Technical Bulletin

Product Update - TB 2112 Rev. A

Compatibility Issues Using Prince XL Spool Guns on Millermatic 250X & 251 Units

Millermatic 251

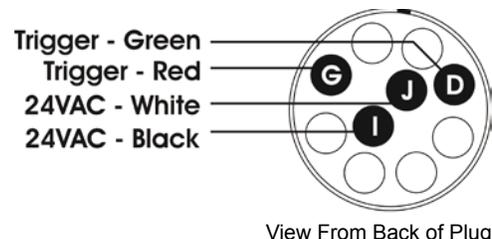
MM251 units after serial number "LC385197" connect as shown. Units prior to this serial number will most likely require a slight modification to bring 24VAC up to the 10-pin receptacle from the internal main control board. Contact Miller Electric for details specific to your serial number.

Millermatic 250X

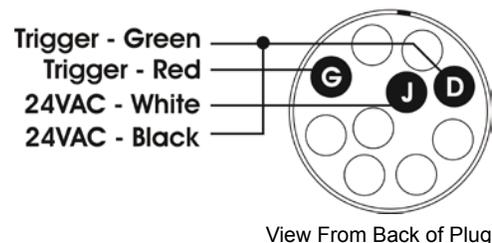
MM250X units are wired differently. The 24VAC supply is routed through one leg of the trigger. Use the MM schematic to verify the connection shown at right. Again, contact Miller Electric for details specific to your serial number.
